**PLANNING COMMISSION SITE PLAN REVIEW SHEET
ENVIRONMENTAL VARIANCE REQUEST ONLY**

CASE: SP-2014-0459C.SH **PLANNING COMMISSION DATE:** July 14, 2015

PROJECT NAME: Live Oak Trails (SMART Housing)

Subject: Live Oak Trails SP-2014-0459C.SH

EXHIBIT 8 - CEF MAP

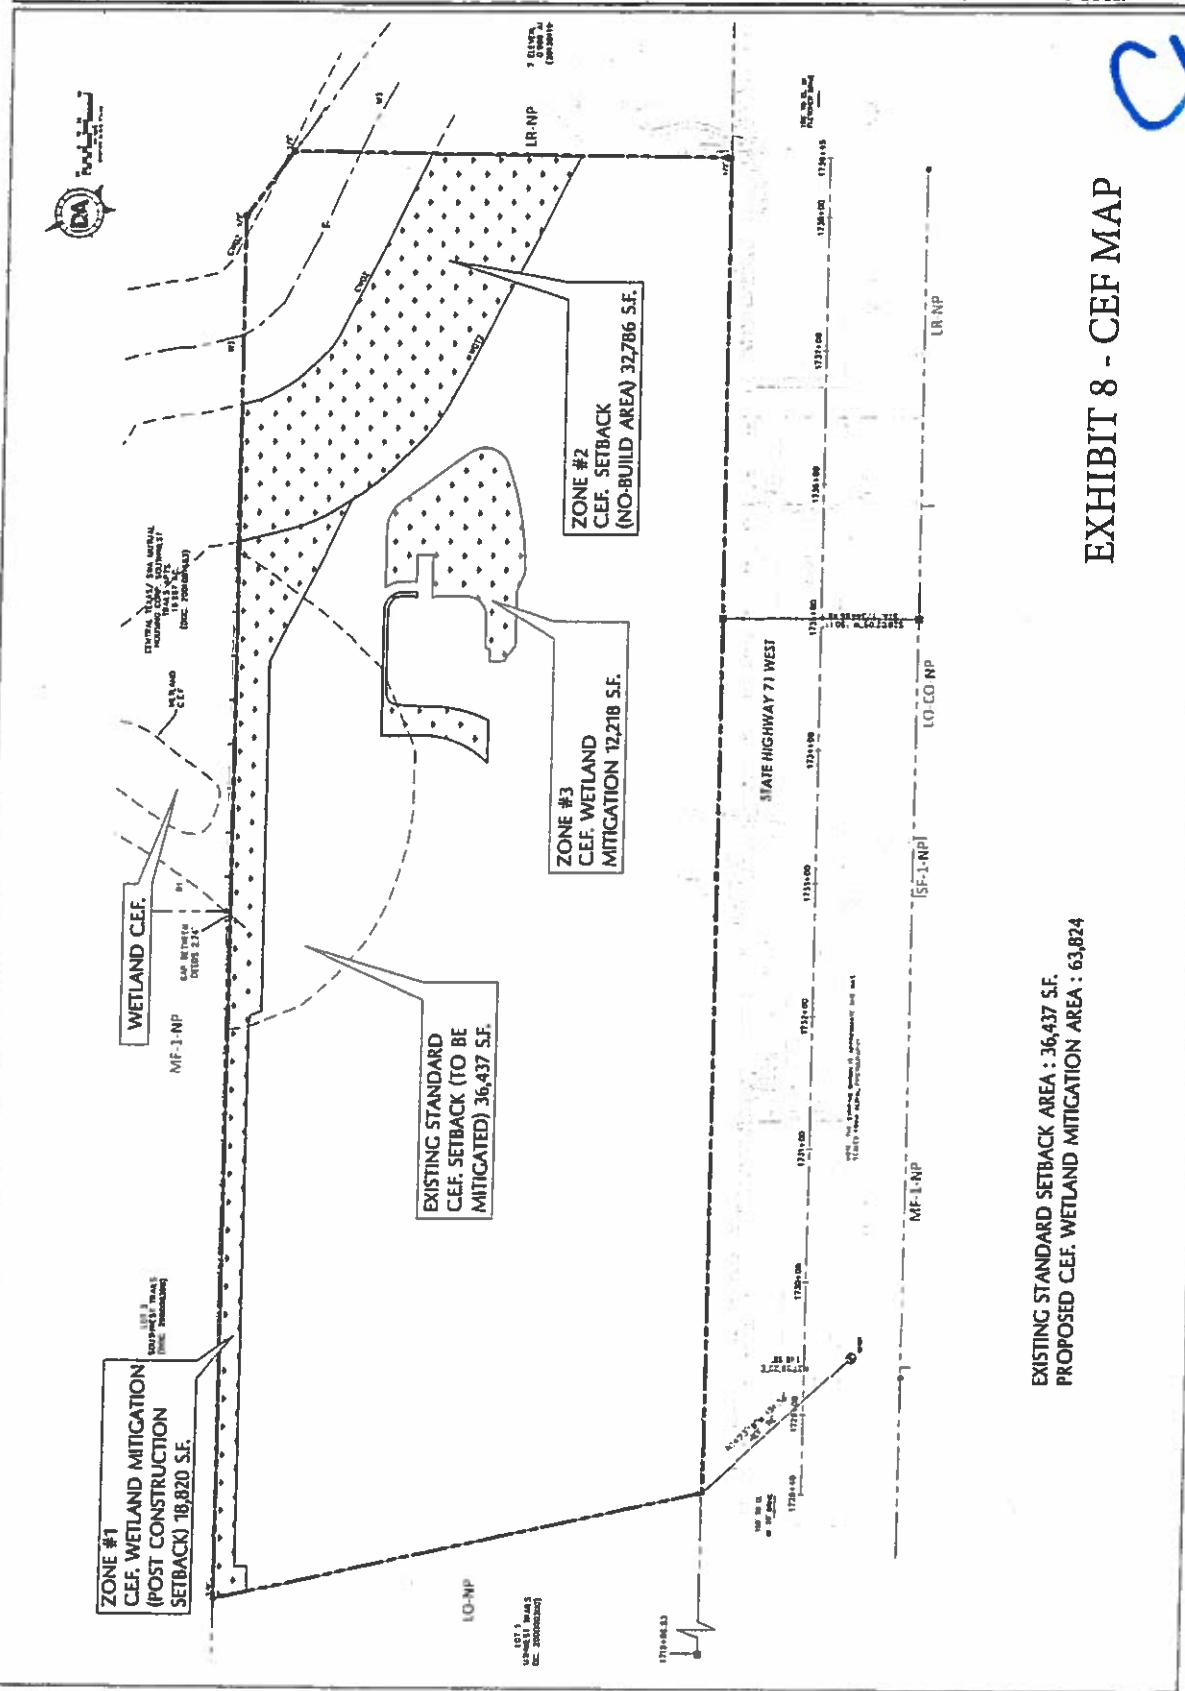
One wetland critical environmental feature (CEF) is located just off-site, less than 30 feet from the northern property boundary (Exhibit 8 Critical Environmental Features Map). The wetland is a small swale with obligate wetland vegetation which receives overland from the northwest. In compliance with the requirements of Environmental Criteria Manual (ECM) 1.10, the applicant has requested and received administrative approval to modify the standard 150 foot CEF setback.
